Agenda
Village of Arlington Heights
Design Commission
Community Room, 3rd Floor

Arlington Heights Village Hall
33 S. Arlington Heights Road
Arlington Heights, IL 60005
February 9, 2016
6:30 PM

**MINUTES OF
THE VILLAGE OF ARLINGTON HEIGHTS
DESIGN COMMISSION MEETING
HELD AT THE ARLINGTON HEIGHTS MUNICIPAL BUILDING
33 S. ARLINGTON HEIGHTS RD.
JANUARY 26, 2016**

Proposed Single Family
Spec House
1806 N. Walnut Avenue
Arlington Heights, Illinois
Developer
5th Avenue Construction

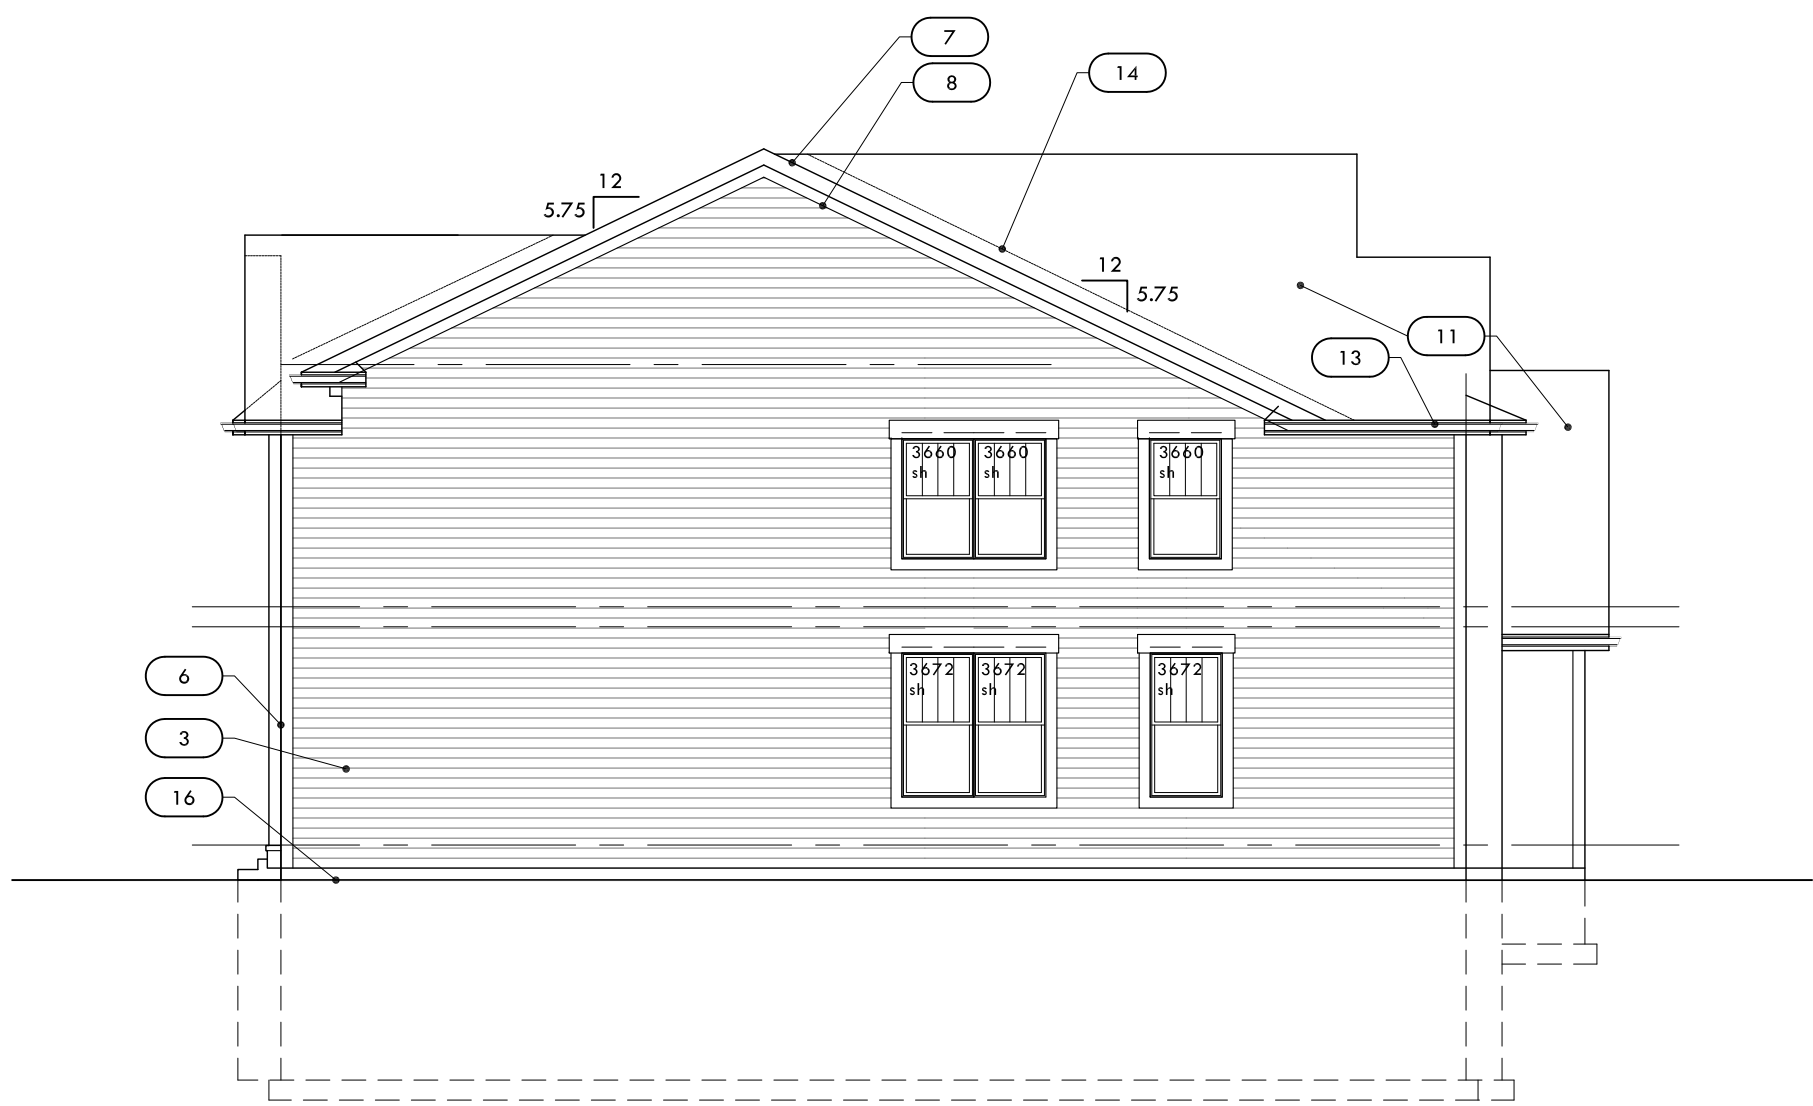
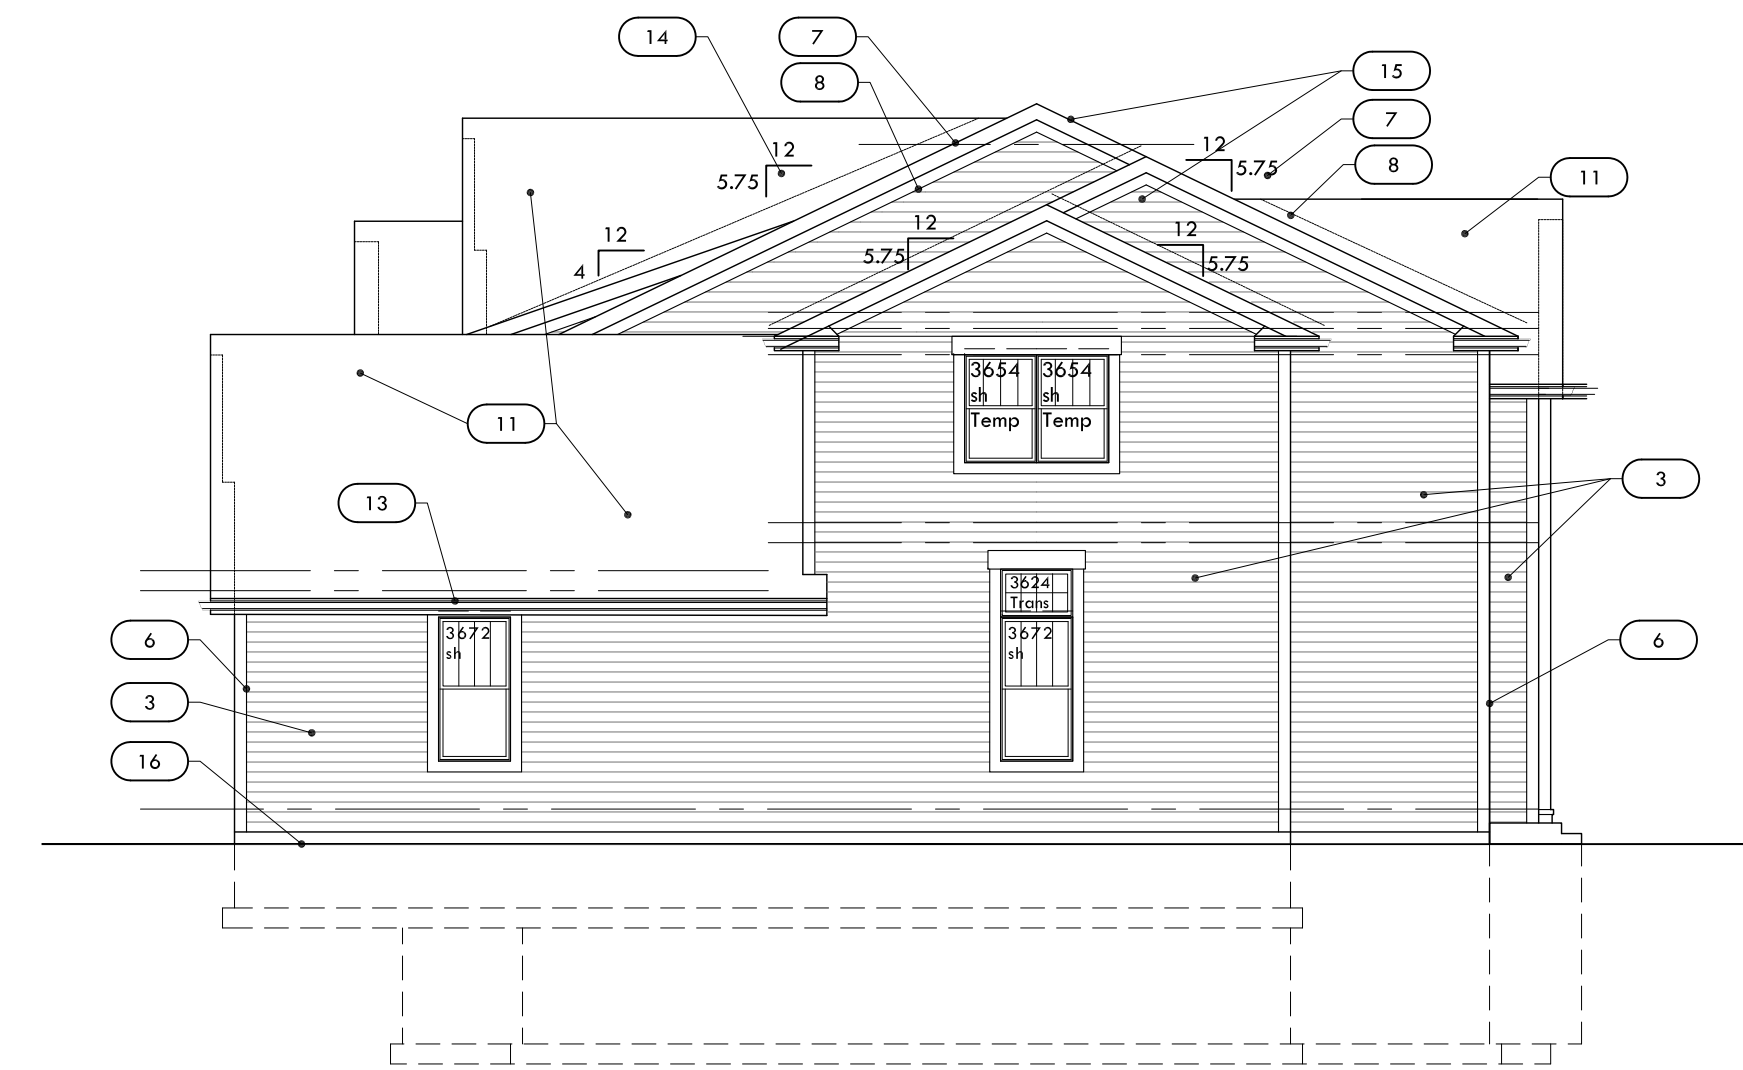
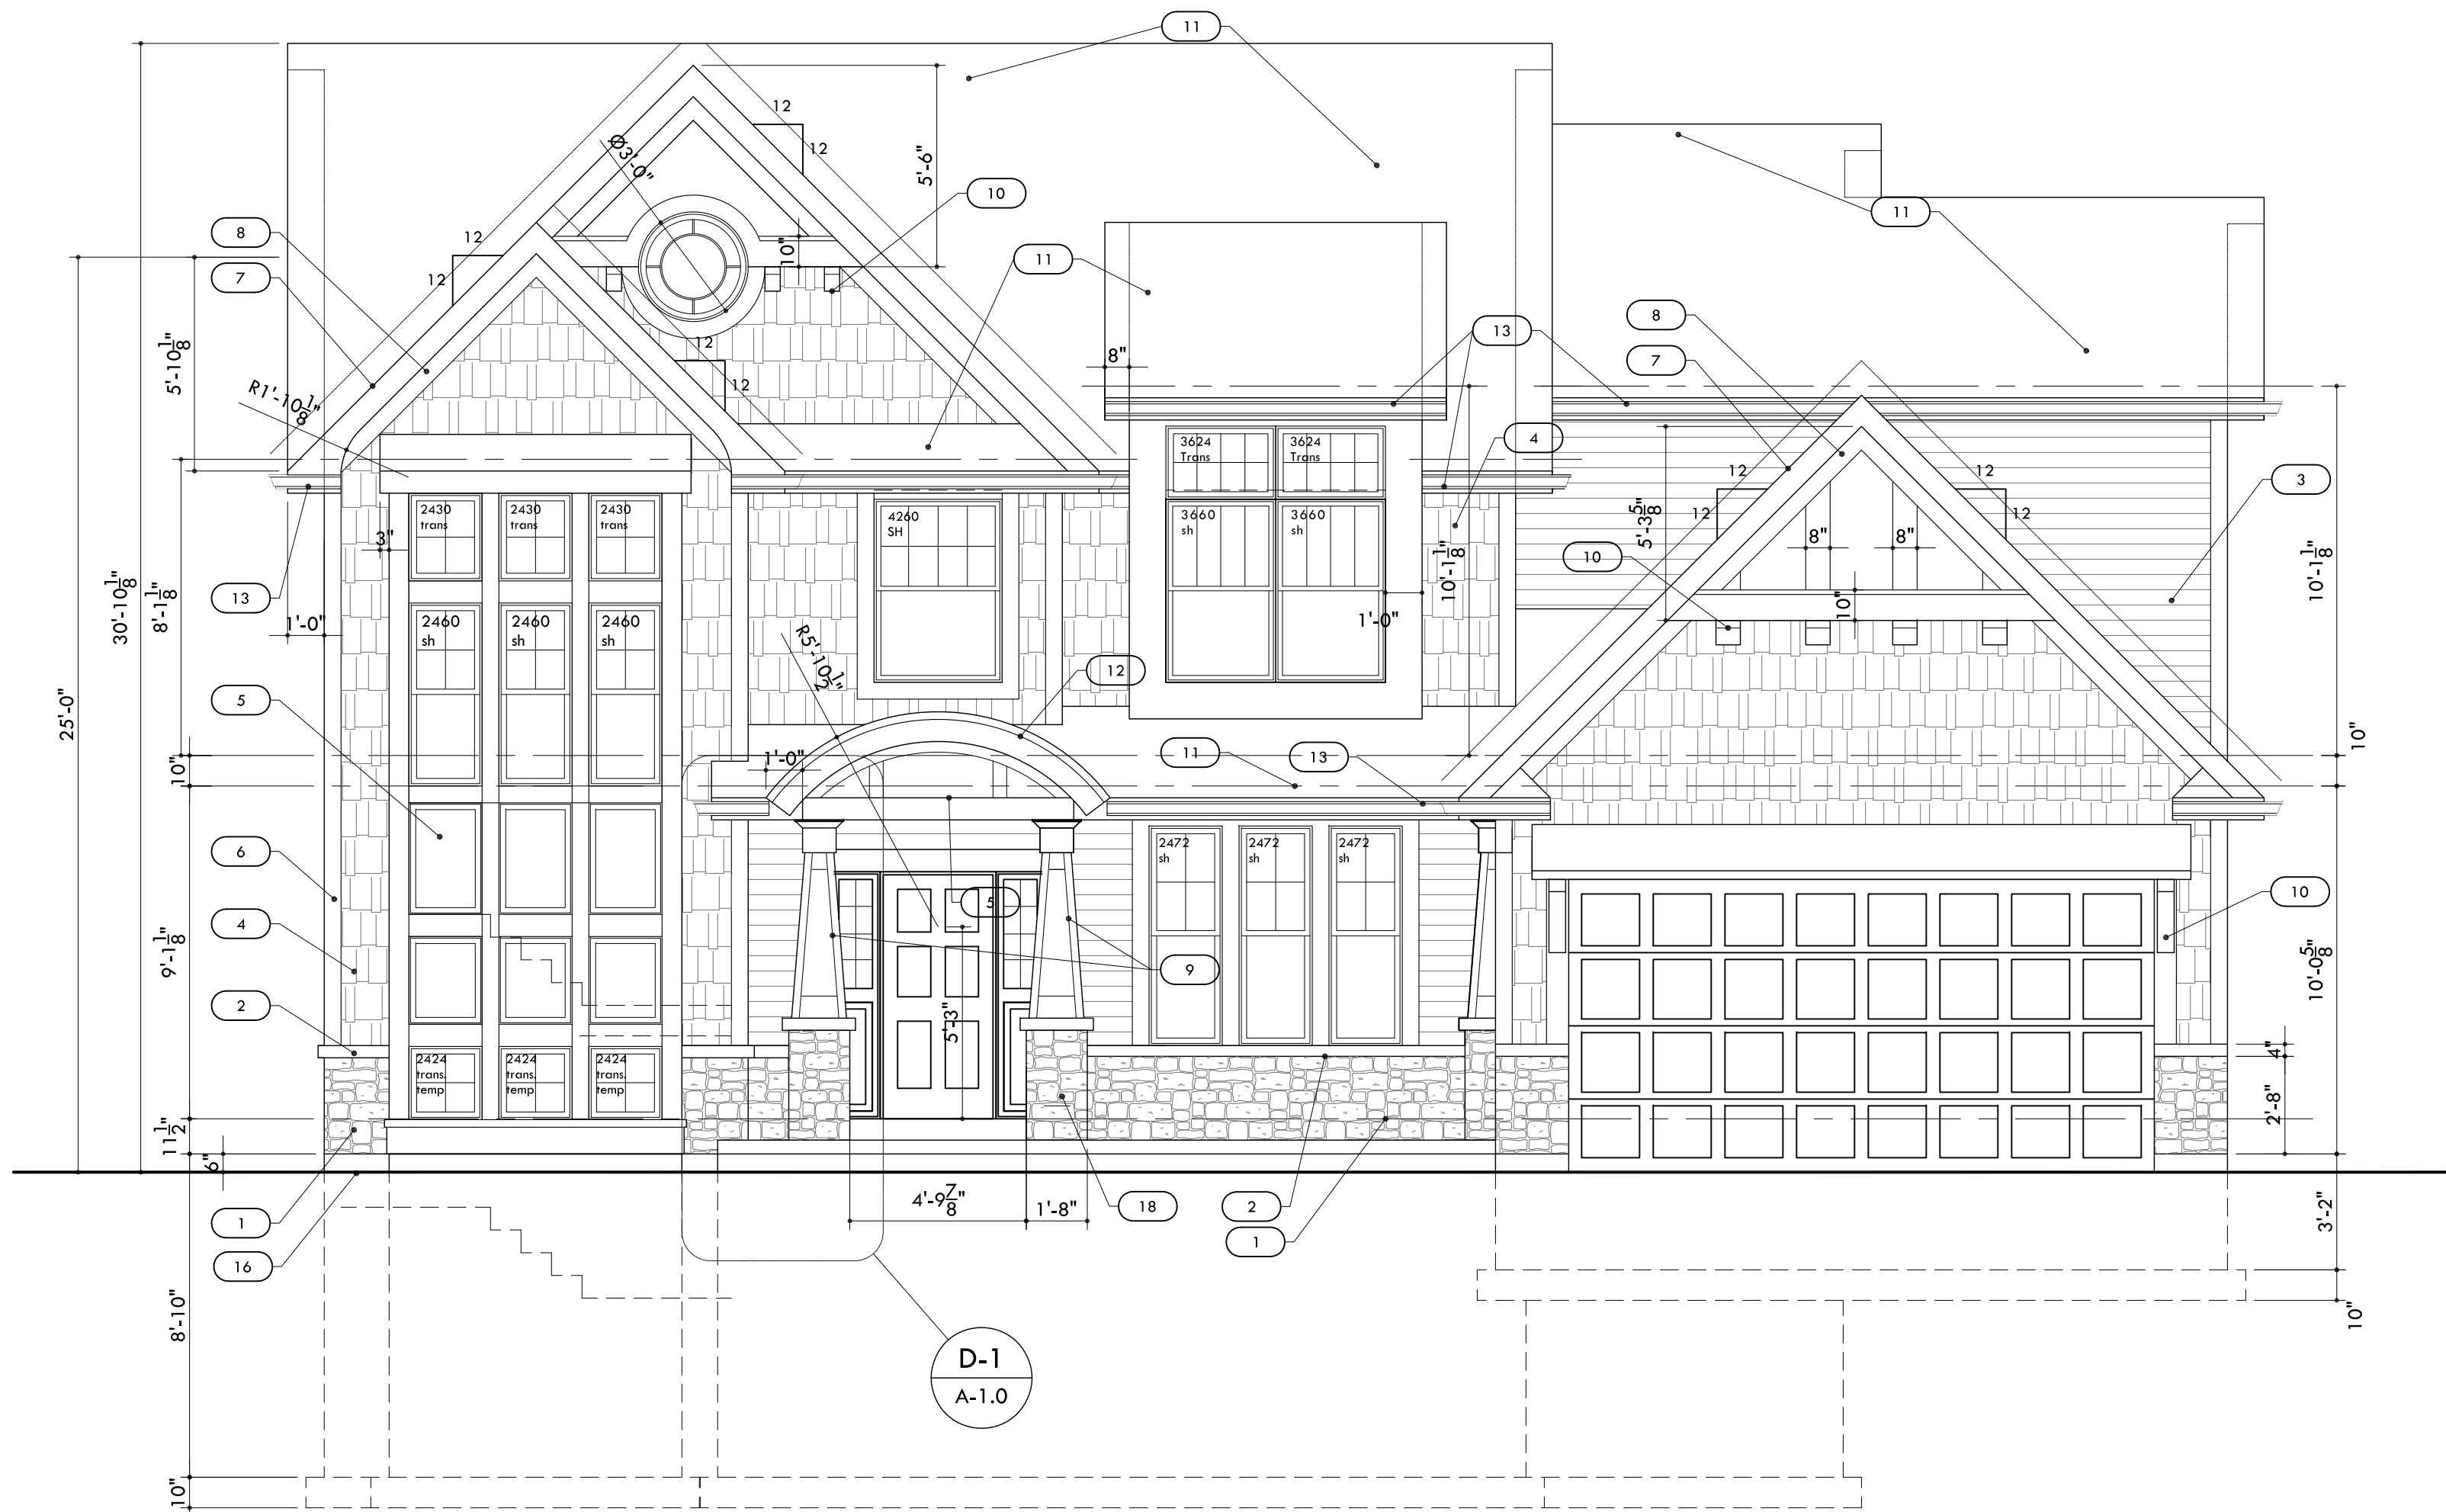
1. Change the two-story bay windows on the front and back of the home to single story.
2. Reduce the height of the second floor dormer on the front of the house by omitting the transom windows.

1. Change the two-story bay windows on the front and back of the home to single story
2. Reduce the height of the second floor dormer on the front of the house by omitting the transom windows.
